RE: FIRE TRAINING PIT CAP INSTITUTIONAL CONTROLS REV1, FAIRBANKS
INTERNATIONAL AIRPORT, FAIRBANKS, ALASKA

Robert Burgess - Comments on:
Fairbanks International Airport Fire Training Pit Institutional Controls Letter Addendum

Exhibit 1: FTP Schematic

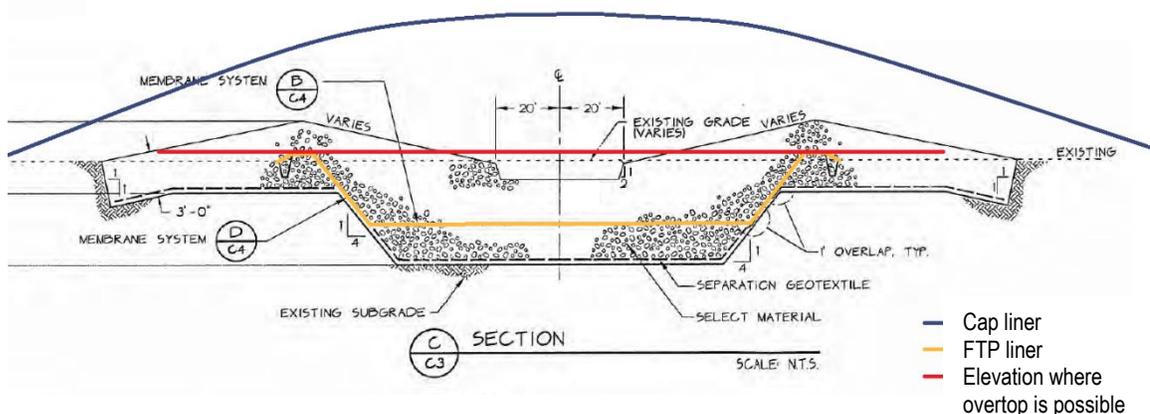
| Cmnt No. | Page | Section | Comment / Recommendation | Response |
|----------|------|---|---|---|
| 1. | 1 | Background | The addendum states, “The lowest elevation where groundwater could potentially overtop the FTP liner within the berms is shown using a red line,” however the actual elevation is never enumerated in text or figures. Please provide the lowest elevation where groundwater could overtop the liner in feet above sea level, and describe how it was determined. | Comment addressed in Background section. |

Exhibit 1 presents a generalized cross-section of the FTP, showing the newly installed cap liner (blue line) with respect to the existing FTP liner (orange line). During the corrective action effort, Shannon & Wilson's contractor uncovered the existing FTP liner at several depths within the compacted soil berms prior to beginning cap construction. The lowest FTP liner elevation within the berms was 430.7 feet above sea level and is considered a

conservative estimate of where groundwater could potentially overtop the FTP liner. This elevation is shown using a red line in Exhibits 1, 2 and 4.

2020 INFORMATION MAP

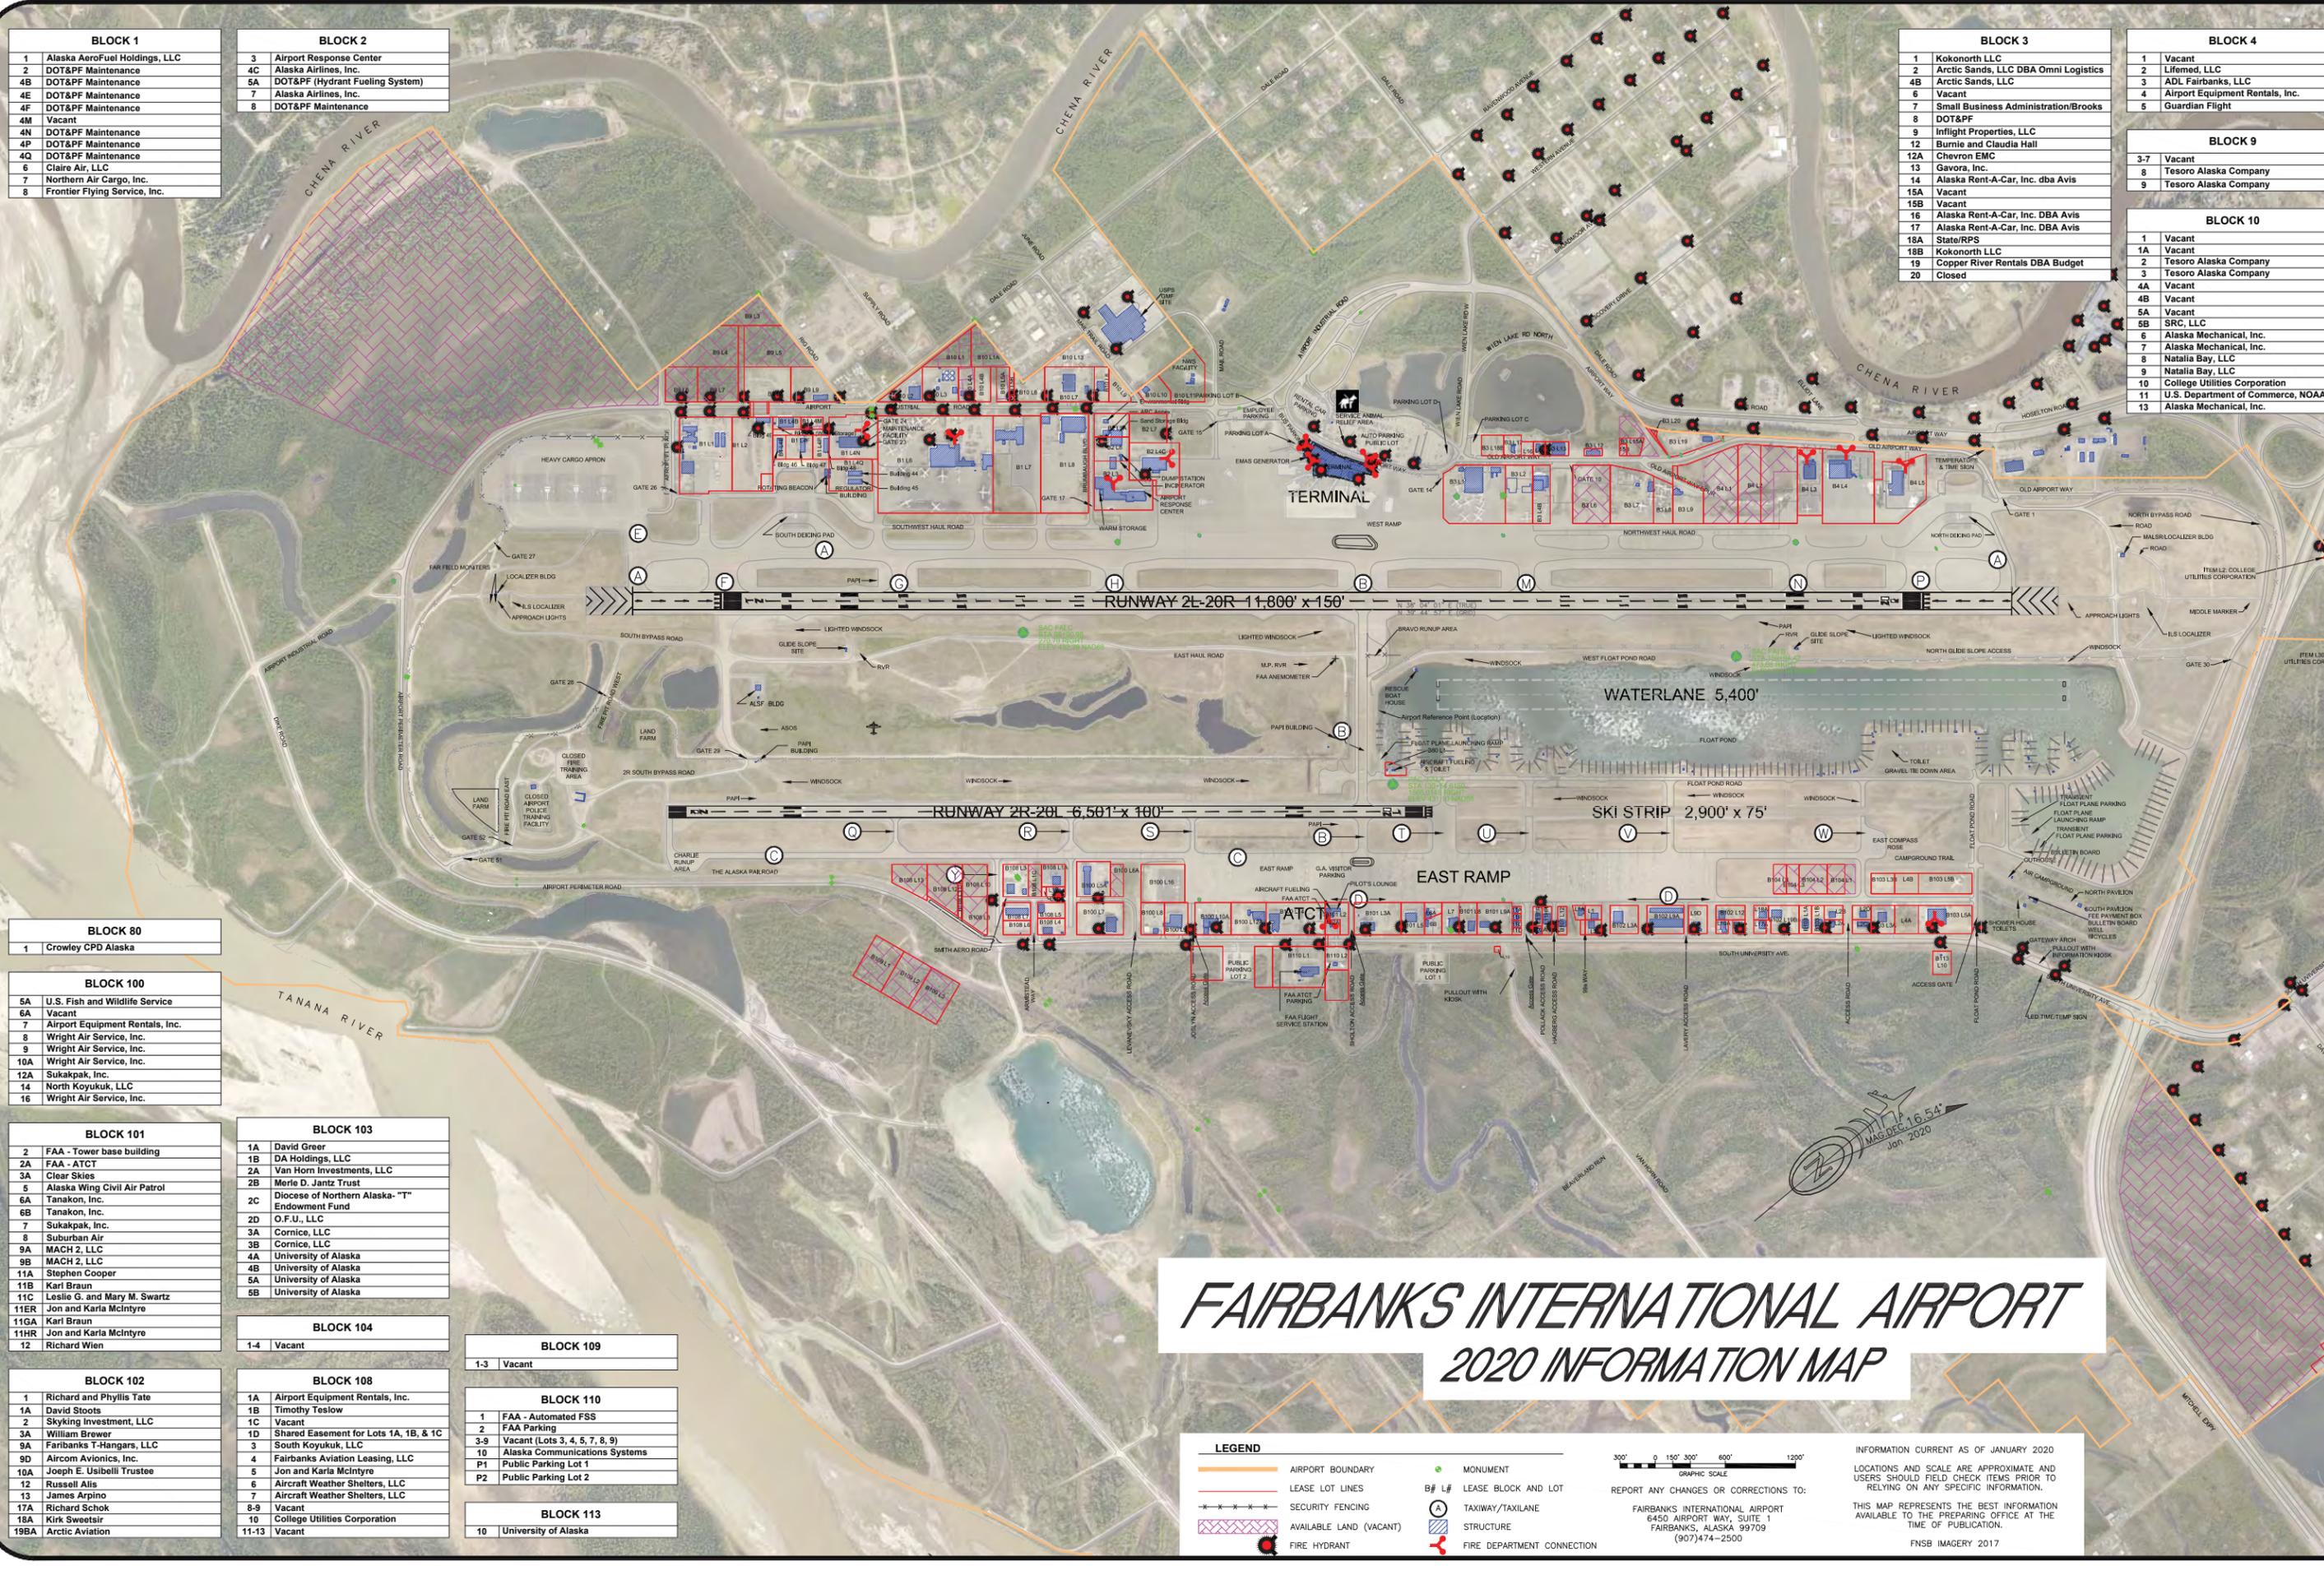
| Cmnt No. | Page | Section | Comment / Recommendation | Response |
|----------|------|---|---|---|
| 2. | 2 | Access | The addendum describes limiting access to the capped area and documentation of this area’s closure on internal maps. Please provide copies of these maps to the DEC and describe the format, use, and storage of these maps. | FAI Engineering maintains the AutoCAD-based FAI Information Map that is universally available in pdf format for reference by FAI staff. A copy of map has been provided. |

The FAI has noted the former FTP on the internal FAI Information Map to inform FAI staff the area is closed, and to prohibit excavation, drilling, or other soil-disturbing activities within the cap boundaries. The Information Map is maintained by FAI Engineering in

AutoCAD and is universally available in pdf format for reference by FAI staff. A copy of the map is appended.
